ORIGINATION FORM

Proposed Revisions to a Standard Plans Index

Index Number: 700-040

Index Title: Cantilever Sign Structure

LAST REVISION	11/01/17	DESCRIPTION:	11/01/22		FY 2022-23 STANDARD PLANS	CANTILEVER SIGN STRUCTURE	INDEX 700-040	SHEET 1 of 5
---------------	----------	--------------	----------	--	------------------------------	---------------------------	------------------	-----------------

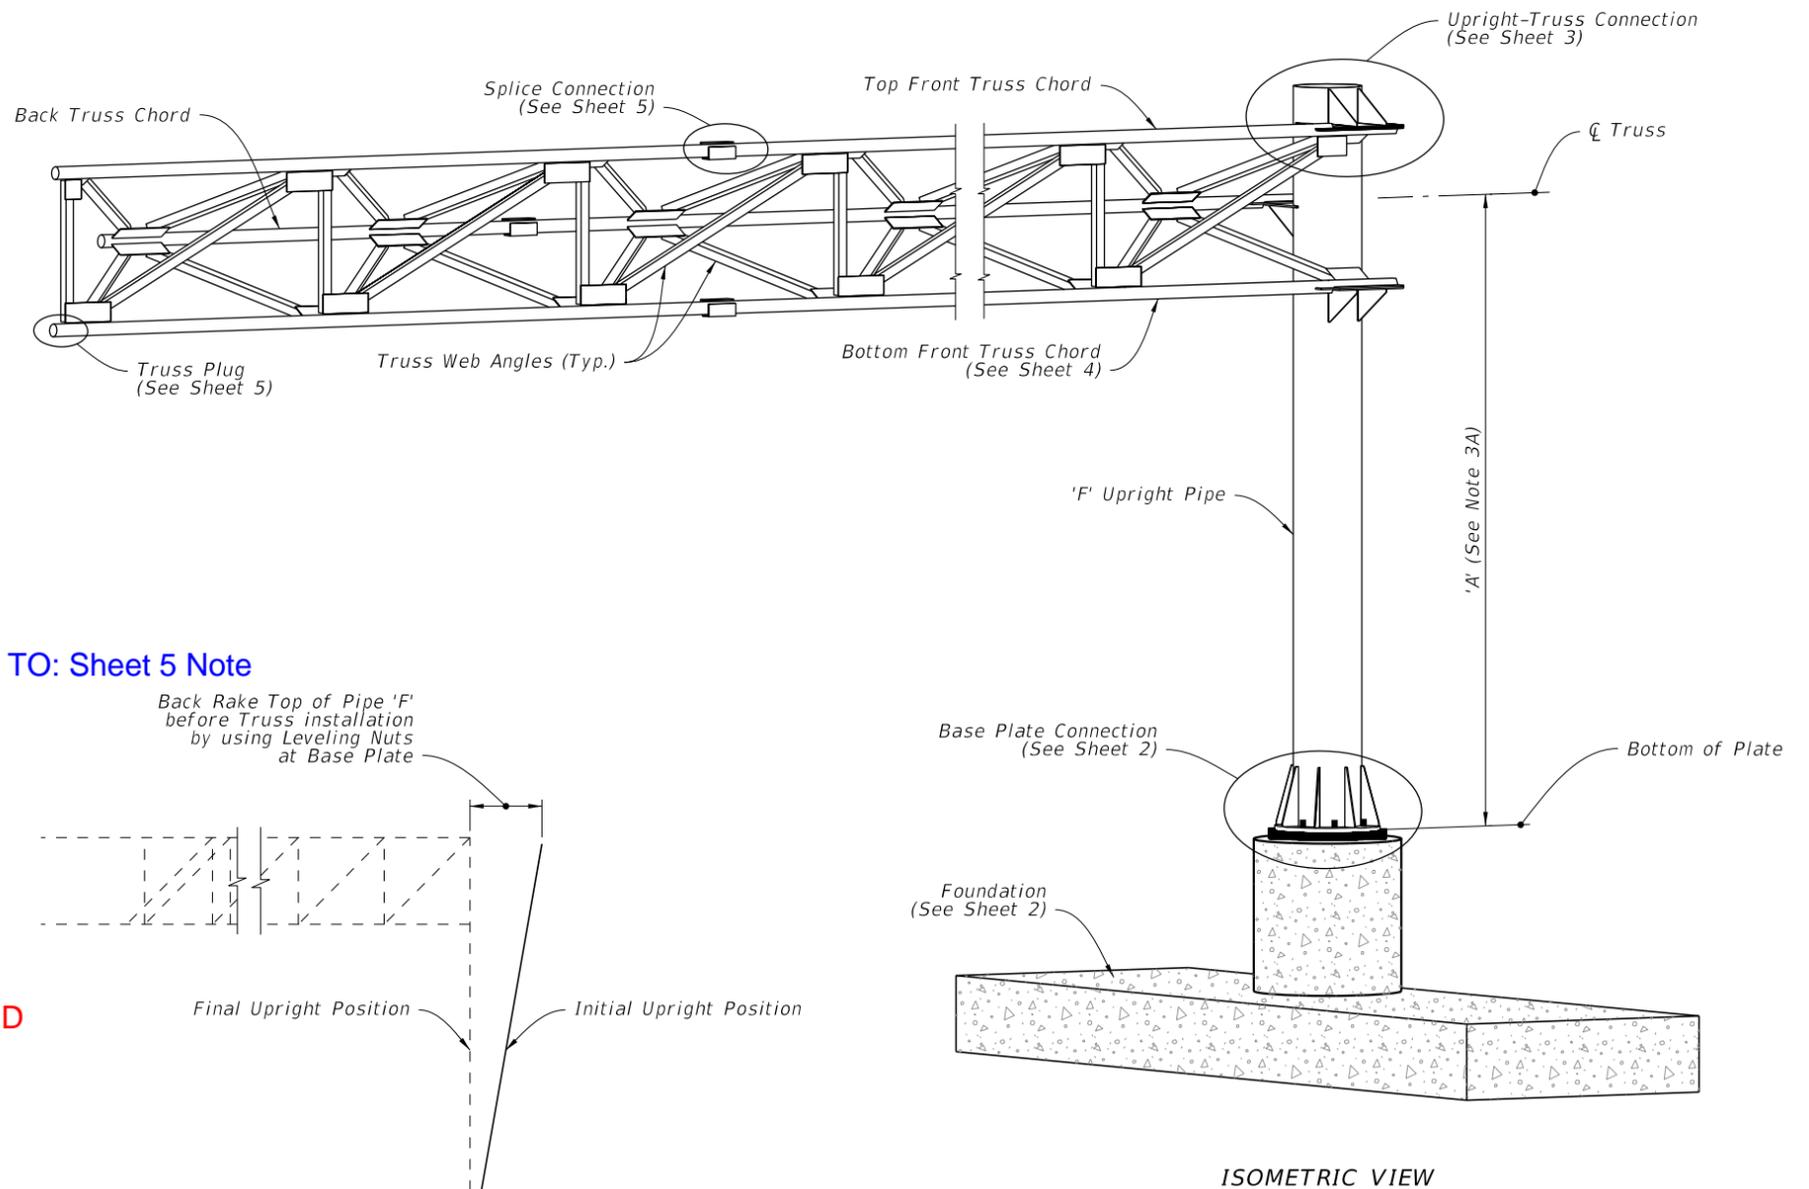
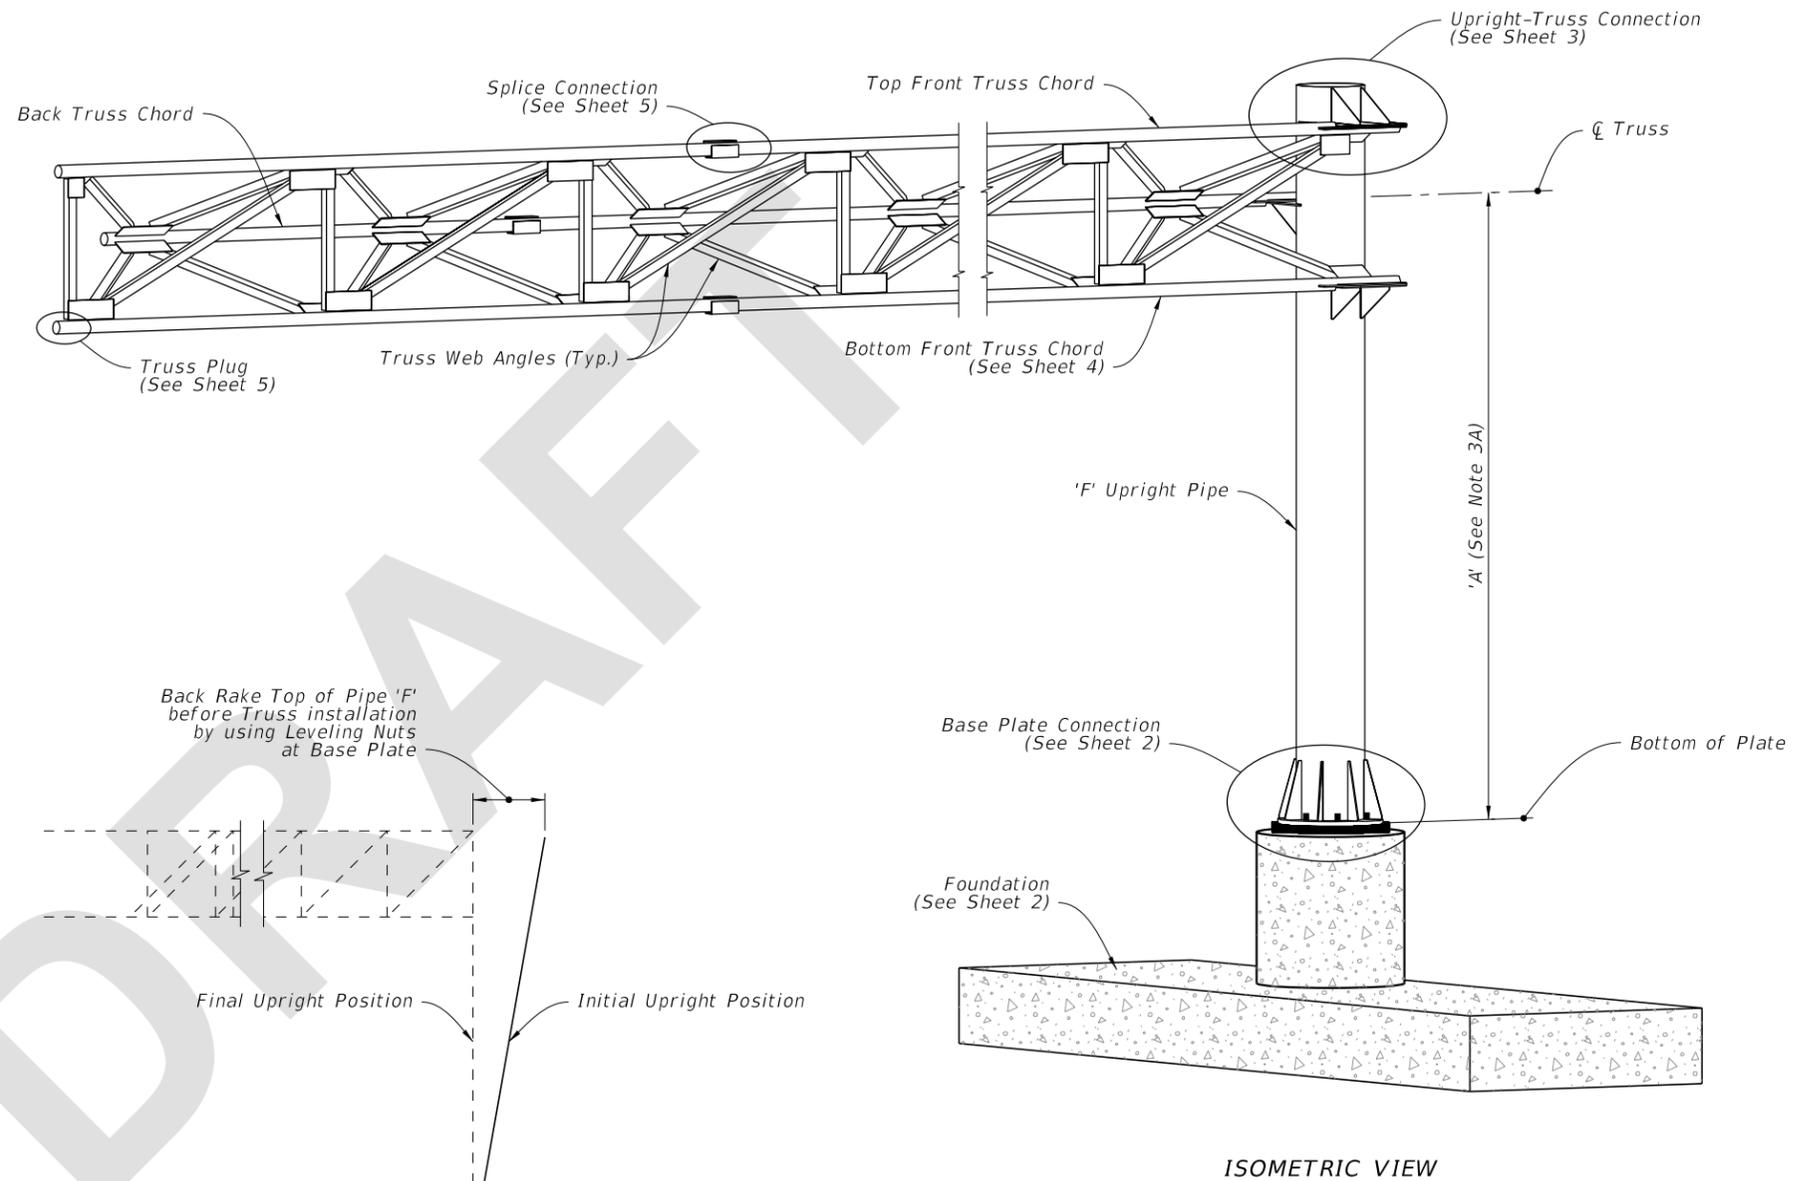
Sheet 1: Updated Notes to General Notes; Added New General Note 1 - "Meet the requirements of Specification 700."; Deleted Notes 4 through 7; Moved Note 5.B to Sheet 5 Notes; Renumbered Notes.

UPDATED: GENERAL NOTES:

ADDED NEW NOTE 1: Meet the requirements of Specification 700.

~~4. Materials:~~

DELETED

~~5. Fabrication:~~

MOVED TO: Sheet 5 Note

~~6. Coatings:~~

DELETED

~~7. Construction:~~

GENERAL COMMENT: Some material, construction, and fabrication information was deleted. Information is either already covered in Standard Specifications OR will be added to Section 700, 962 or 965 in conjunction with these revisions.

1. Meet the requirements of Specification 700.
2. Work this Index in conjunction with CANTILEVER SIGN STRUCTURE DATA TABLES in the Plans and Index 700-030.
3. Handholes are required at pole base for DMS Structures. Refer to Index 700-090 for Handhole Details.
4. Shop Drawings are required.
